1609 N Tejon Street

An application for a Report of Acceptability for a 260 square feet front porch and a 1,400 square feet addition to the rear of the house.

File Number	Application Type	Decision Type
HIST-25-0002	Report of Acceptability	Quasi-Judicial

1 Proposed View From Southwest

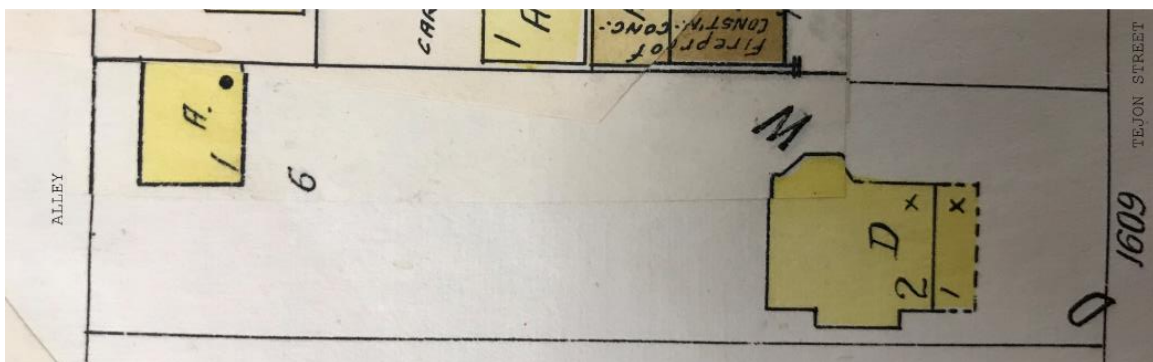
A proposed front porch addition is very appropriate for this home. This is supported by the Sanborn Map, the described architectural style in the “National Register of Historic Places – Nomination Form,” and that there are similar homes in the Old North End with the same architectural characteristics that do have front porches. A compatible design would be a simple shed porch roof with or without a pediment, support columns and railings. The proposed project meets the characteristics of porches in the North End Historic District in terms of location, scale, materials, and quality.

The proposed project does not impact on the architectural style of the main house and its relation to the other historical residences in the HP-O district. It re-establishes primary elements of front porches in the Old North End Neighborhood, and it does not take away from the prominent features of the home. An example is the very prominent gable roof over the front porch.
